**Objection to Development Application 2022/1128 at 38 The Drive,
Freshwater**

**AMENDED ARCHITECTURAL PLANS AND OTHER DOCUMENTS RELATING
TO DEMOLITION OF EXISTING DWELLING HOUSE AND CONSTRUCTION
OF A NEW PRINCIPAL DWELLING AND A DETACHED SECONDARY
DWELLING OVER A GARAGE, TOGETHER WITH A SWIMMING POOL &
LANDSCAPING
PROPERTY: 38 THE DRIVE FRESHWATER (DA 2022/1128)**

Figure 2: Diagram showing positions and RL's for photographs taken from future 1st floor level of dwelling house under construction (Courtesy Poppy Bevan Architect)

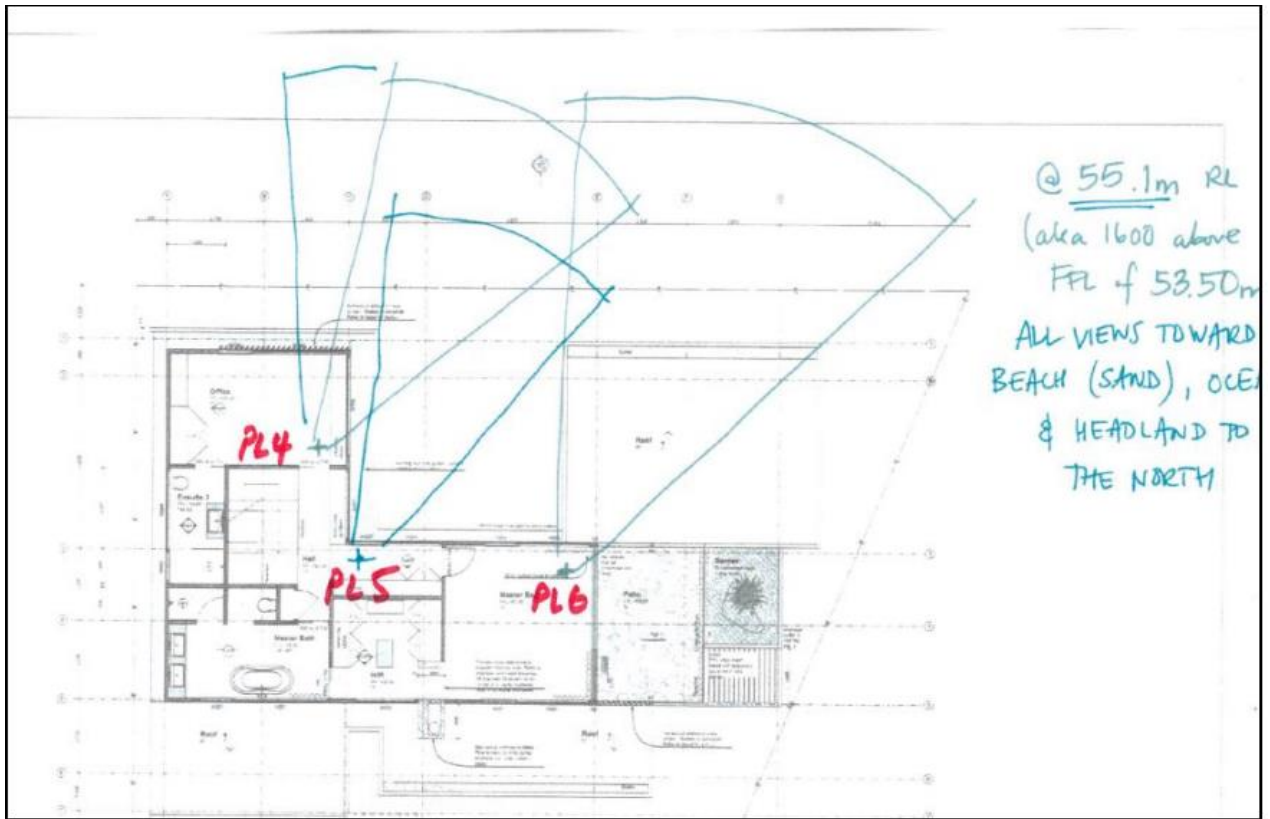
PL-1 is taken from the proposed location of our clients' pool area. Whilst the view of the horizon is impacted from this location, this photograph clearly demonstrates the overwhelming bulk of the proposed development along the southern boundary shared with our clients. This will significantly affect our clients' privacy and right to use and enjoy their property.

PL-2: Before

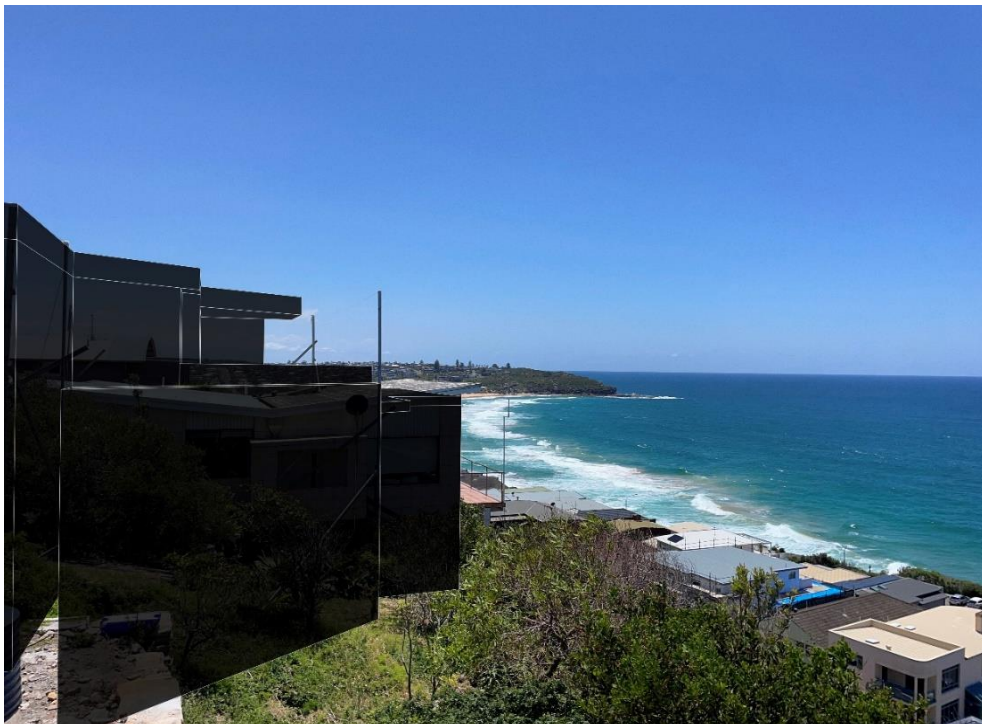
PL-2 shows demonstratable loss of the remaining views of the headland that are not previously compromised by the existing dwelling on the site.

PL-5: Before

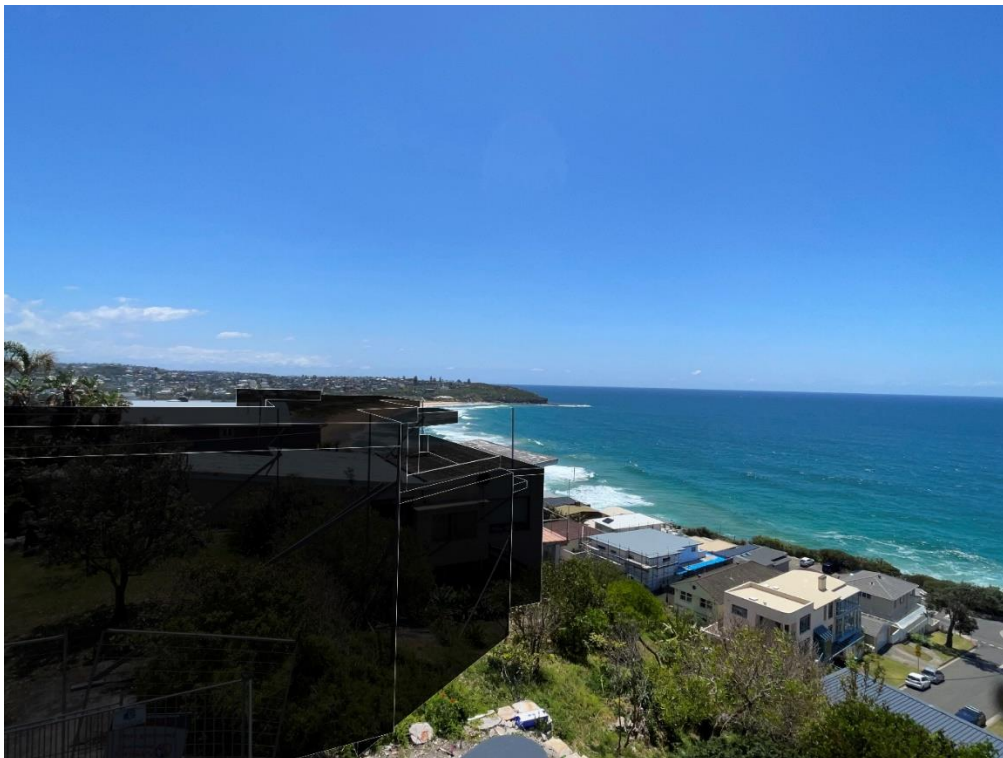
PL-5 is taken from the upper level of our clients' dwelling. This photograph shows total obliteration of our clients' view of North Curl Curl Beach and the land sea interface. Significant parts of the ocean and headland views are also severely impacted.

Figure 1 – Diagram Showing Juxtaposition of Proposed Development and Our Clients Dwelling House (Currently Under Construction) With 'Privacy Field of Influence' Overlaid
Courtesy Poppy Bevan Architect

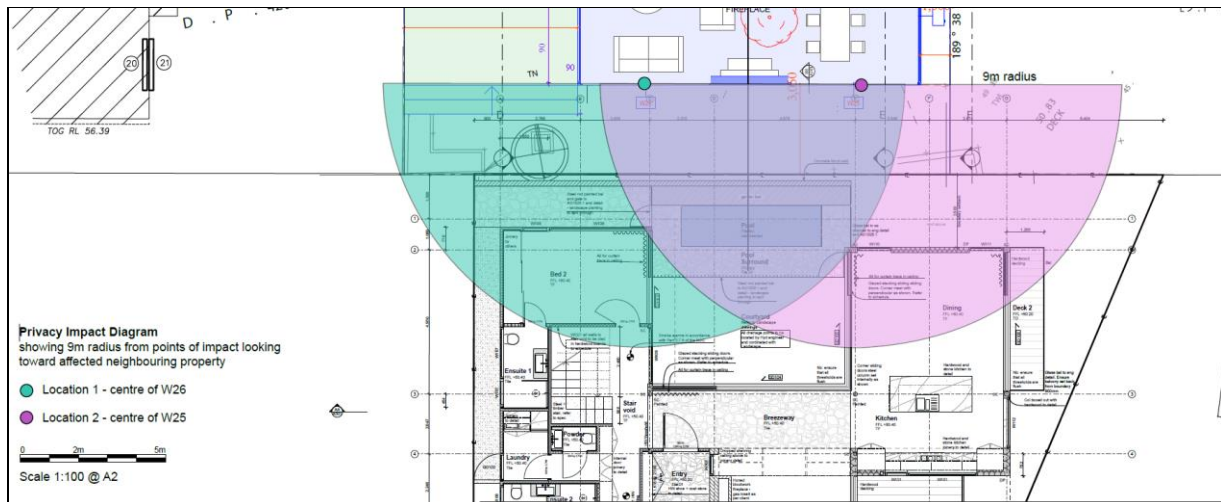
In terms of the privacy matter, the proximity of the proposed development to our clients' property, the entertainment/living room purpose of the rooms from which the overlooking occurs, the position of windows parallel to the common boundary and the overall height of the development, will combine to create a completely unacceptable visual privacy impact on our clients' property.

In the present case it is abundantly clear that the dwelling designer has virtually ignored the privacy issue that arises as a result of these large picture windows on the south side of the dwelling (W25 and W26). The sole objective appears to involve maximising the southerly views from the new dwelling, despite a significant 'cost' in terms of neighbour amenity as regards the Key residence. Whilst there is an opportunity for landscaping between built elements, as is stated in *Meriton v Sydney City Council* above, this should not be relied on and must be given little weight in a notional planning assessment. In this case the designer has completely failed to address this significant issue. The only, we say tokenistic, concession that has been made is the raising of the sill height of window W25 to 1m. With respect, this does nothing to assist with ameliorating the privacy impact.

Figure 2 – South Elevation Extract from
Amended Master Plan Set 'SketchArc' Sheet 13
Note: AW denotes Aluminium Window

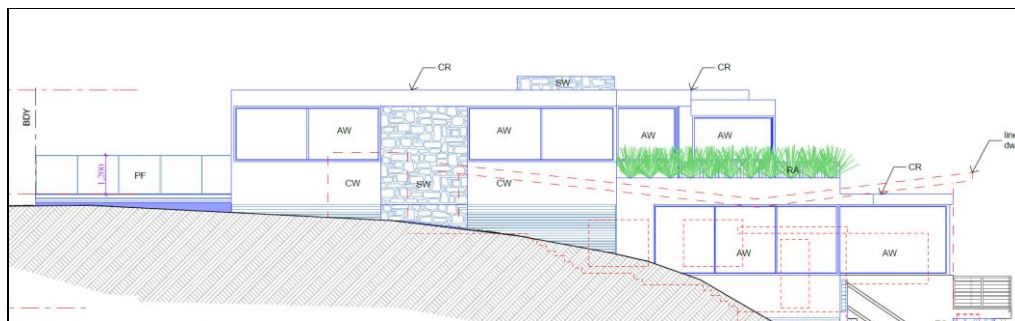
The extract from the designers drawings under, further graphically illustrate the impacts caused by the large 'picture' windows on the southern elevation. We submit this could have been avoided with an improved/reworked design. We must assume the applicant has been granted the ability to deal with the issue by way of acceptance by Council of revised drawings, but has rather decided to ignore the issue.

We have further reviewed the amended set of architectural plans and other documents and can only conclude that a severe visual privacy concern remains for our clients, by reason of proposed windows 25 and 26. The occupant of this new dwelling will be able to look directly into our client's principal private open space and main living area. Such a state of affairs is demonstrably and self-evidently unacceptable.

showing 9m radius from points of impact looking toward affected neighbouring property

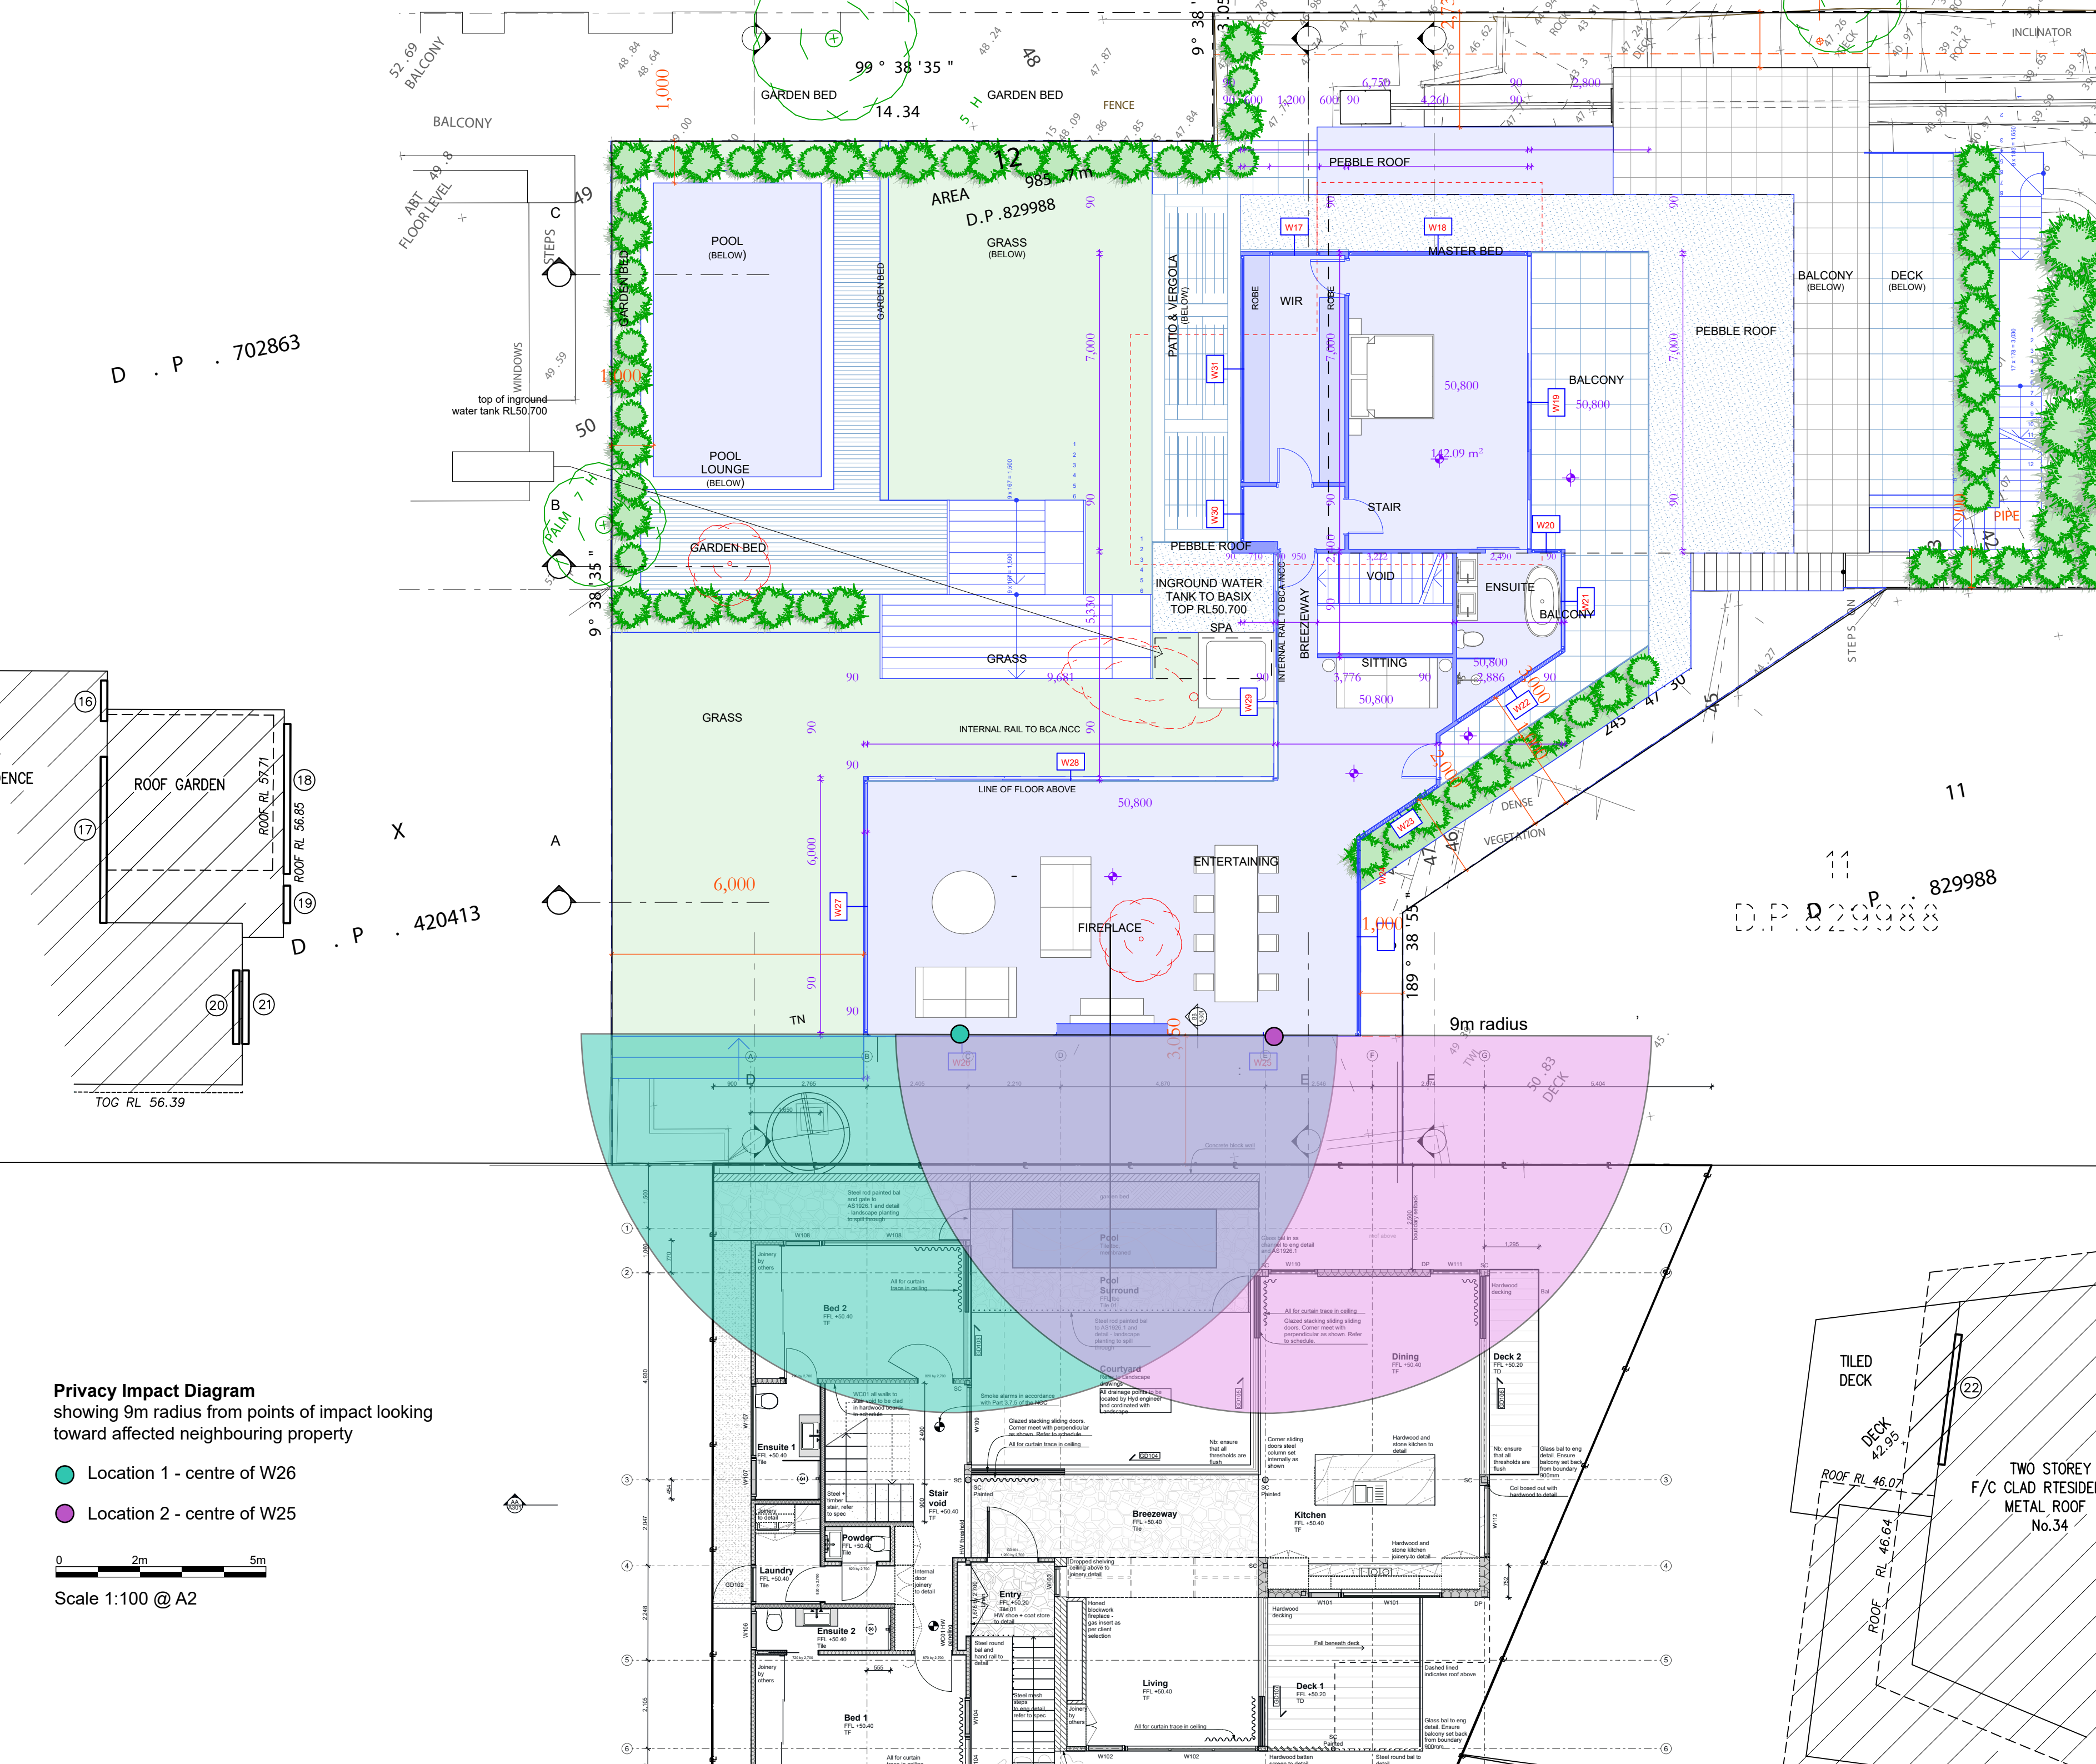
5.7 Further, a marked up 2D impact diagram is at Annexure G and shows a 9-metre radius from points of impact of looking towards our clients' property. The impact diagram shows that the location of W25 and W26 are such that they provide close views that are less than 9 metres away from W108 of Bed 2, W110 of Dining and complete view into the outside pool area in our clients' property. This will result in an unacceptable impact on our clients' privacy and right to use and enjoyment of these spaces.

In order to create the Privacy Impact diagram, we drew several arcs of 90mm radius on the 2D plan overlay. These arcs represent a 9m radius as derived from the 1:100 scale of the drawing. These arcs were located at the centre of each proposed window W25 and W26 in order to outline the impact of overlooking and privacy from the proposed design on the under construction project at 1 Seddon Hill Road. This composite document was released and entitled "Survey and 2D plans - Privacy Impact - scale 1-100 @ A2".
